XONE:92

PARTS IDENTIFICATION DOCUMENT

ISSUE 6.0

003-142 PCB ASSY XONE:92 CONN

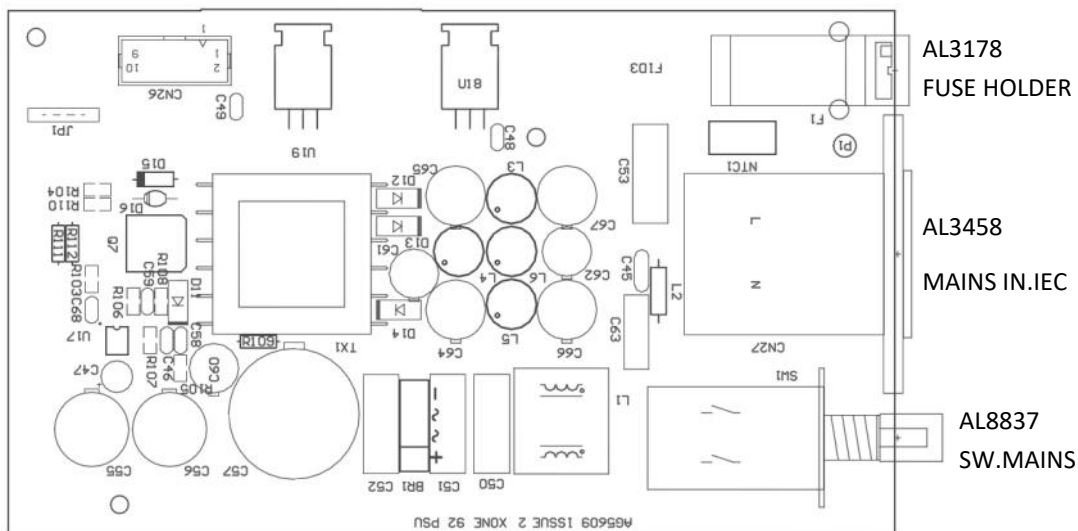
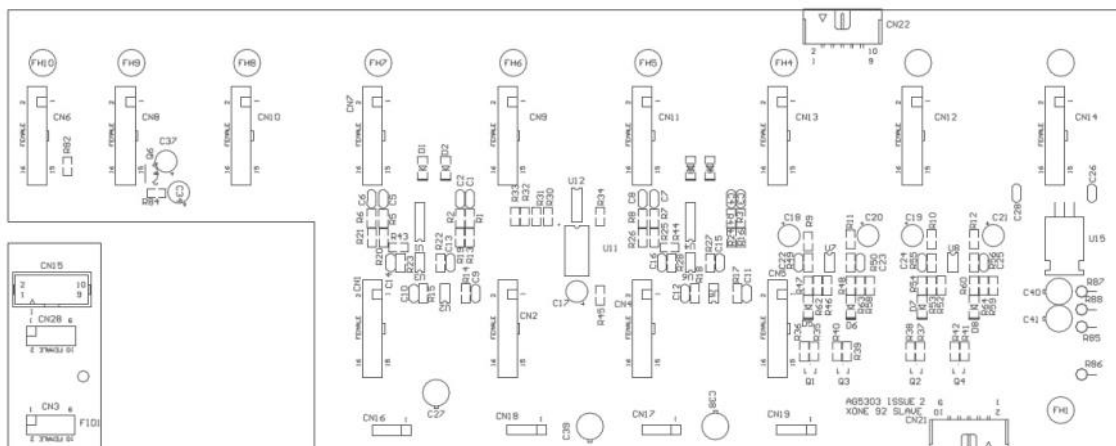
004-1406 assemblies (new AM5547_1, AG5609 **issue 6** and *modified* AG5609 Issue 4 PCBs) **must only be used on products with ECN4660 earthing implemented.**

Where 004-1406X is supplied in replacement for spares or service, parts fitted preceding ECN4660 and units below serial# X92/220X989024 **must** be updated in line with ECN4660 changes.

003-233X only use on product pre ECN4660

004-1406X only use on product post ECN4660

Refer to **REC4660** for required **003-142** and **004-244** modification.

004-244 PCB ASSY XONE:92 SLAVE

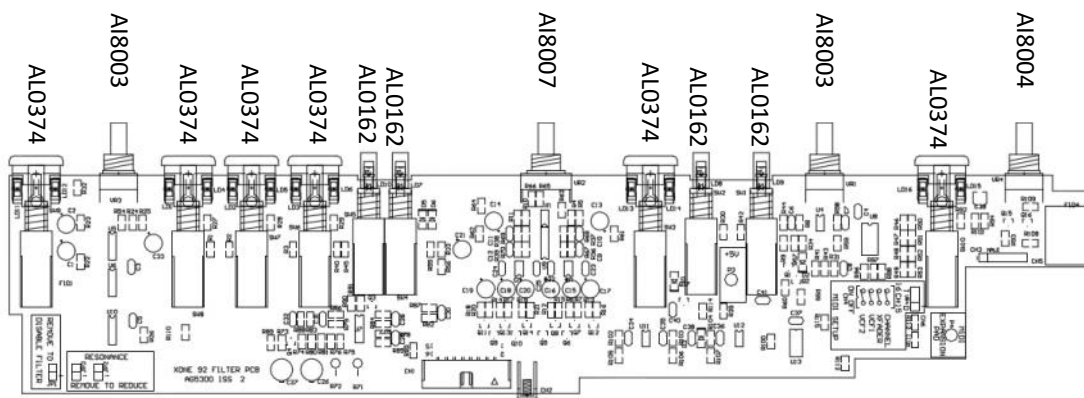
Slave original PCB 003-141 has been up issued to 004-244 .

Do not fit 003-141 in place of a 004-244

SUBJECT: Filter PCB Compatibility
 DATE: 05/12/14
 DOCUMENT: Compatibility Document
 MODEL(S): Xone:92 Xone:92-R

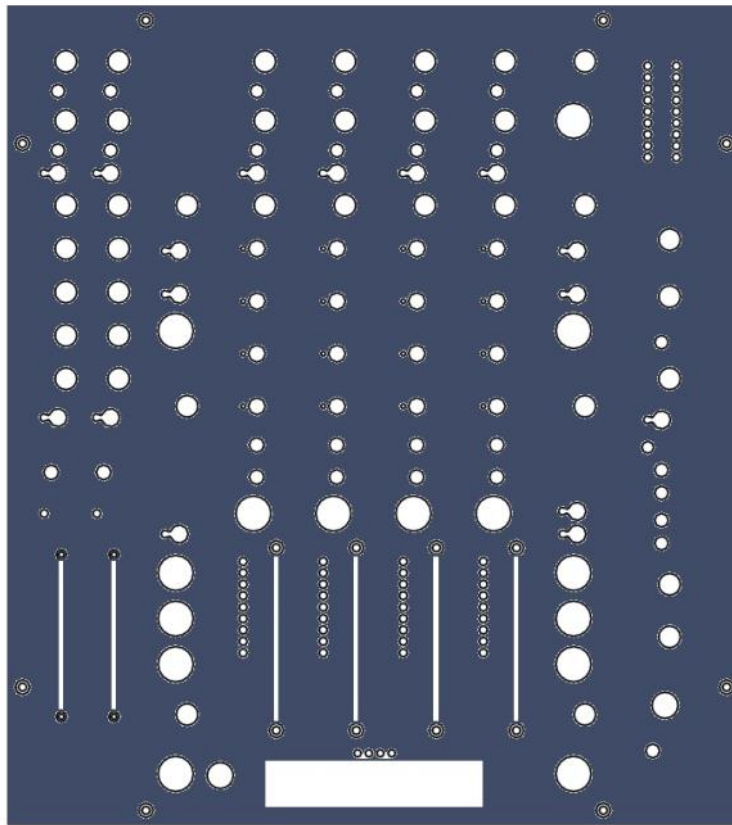
Due to components going obsolete, filter PCBs had to be up-issued. This resulted in back compatibility issues.

The chart shown here illustrates which PCB part numbers are compatible, should one have to be replaced for repair.

Refer to [REC N 3057](#) for details of the component changes
